**SUBJECT: COMANCHE PEAK NUCLEAR POWER PLANT, UNITS 3 AND 4
DOCKET NUMBERS 52-034 AND 52-035
RESPONSE TO REQUEST FOR ADDITIONAL INFORMATION NO. 2994**

**Response to Request for Additional Information No. 2994 (CP RAI #108)
Question 03.08.04-1 (Public Version)**

QUESTION NO.: 03.08.04-1

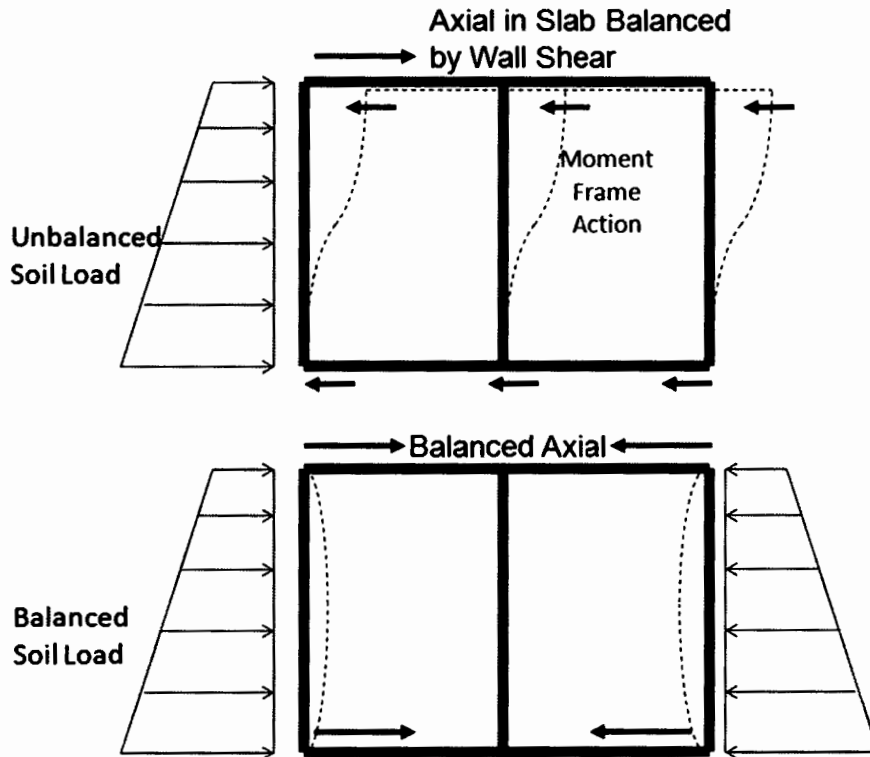
The applicant is requested to explain the direction of the "axial force" mentioned in the above quoted sentence. Is it in the direction of the central axis of the tunnel?

The axial force in the statement quoted from Subsection 3.8.4.4.3.1 is horizontal force within the slab which is axial in the transverse direction of the tunnel due to unbalanced soil load on the exterior walls.

This statement is illustrated in the figure below showing only the horizontal, at-rest soil pressures on the sides of the tunnel. In the top figure, the axial force in the roof and mat slab is unbalanced by soil pressure on the other side. The axial force in the roof translates to out-of-plane shear in the walls,

which causes the moment frame action of the tunnel. In the bottom figure, the soil pressure on both sides balances the axial force in the roof and mat slab.

Tunnel Segment 1 including surrounding soil layers and fill beneath

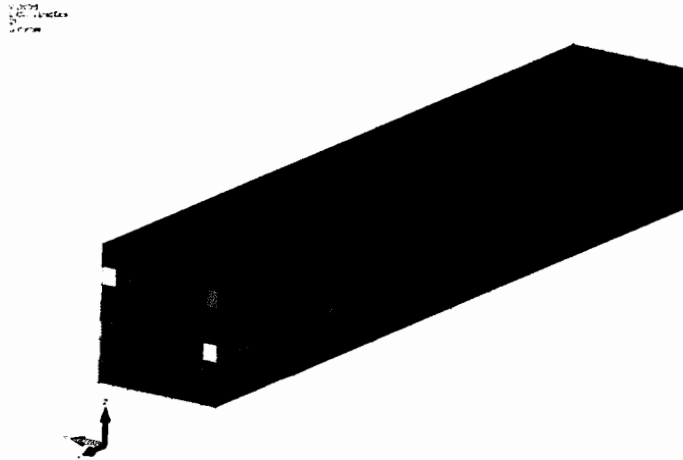
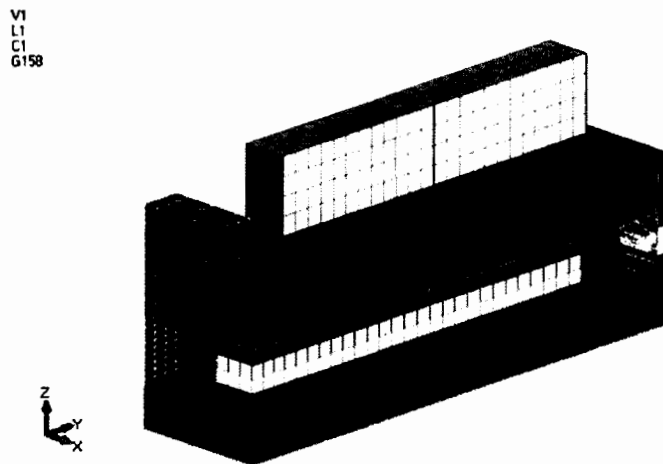
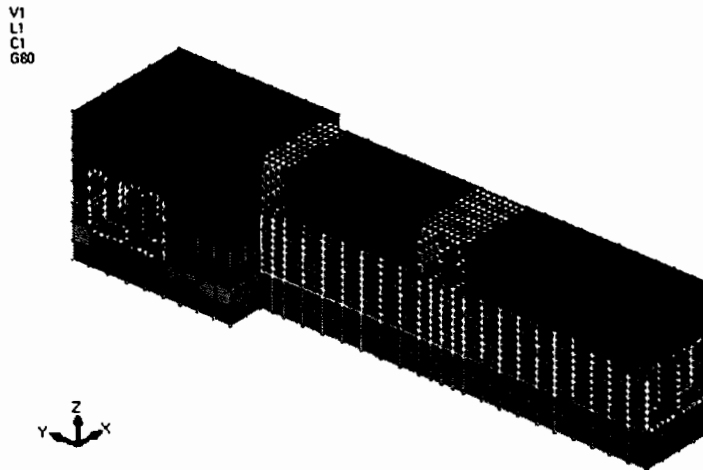
- (a) The first sentence of the above quoted paragraph discussed only the dynamic forces oriented parallel to the length of the tunnel segment. Provide a similar description for dynamic forces perpendicular to the length of the tunnel segment.
 - (b) Provide detailed information that shows how the static and dynamic soil pressure is calculated in accordance with ASCE 4-98.
-

- (b) The static soil pressures are not calculated using ASCE 4-98. The static soil pressures were calculated using at-rest pressures with $K_0 = 0.47$. This is the same as the at-rest pressure coefficient given in Figure 2.5.4-243 of the FSAR. The design also considered the load from the overburden pressure and the soil compaction pressure.

The seismic soil pressures are calculated directly in the SASSI analyses and are applied as equivalent static pressures in the ANSYS design model. The equivalent static seismic soil pressures applied in the ANSYS design model are shown to be conservative when compared to the calculated elastic solution used in ASCE 4-98 based on J.H. Wood, 1973 and the enveloped SASSI results. For calculation of the seismic soil pressures based on ASCE 4-98, the soil acceleration was taken as 1.5 times the ZPA of the spectrum at El. 782' (bottom of fill concrete) for tunnel segments 1 and 3 and 2.0 times this ZPA for tunnel segment 2. The value of C_v was taken equal to 0.99. The soil unit weight was taken as 125 pcf.
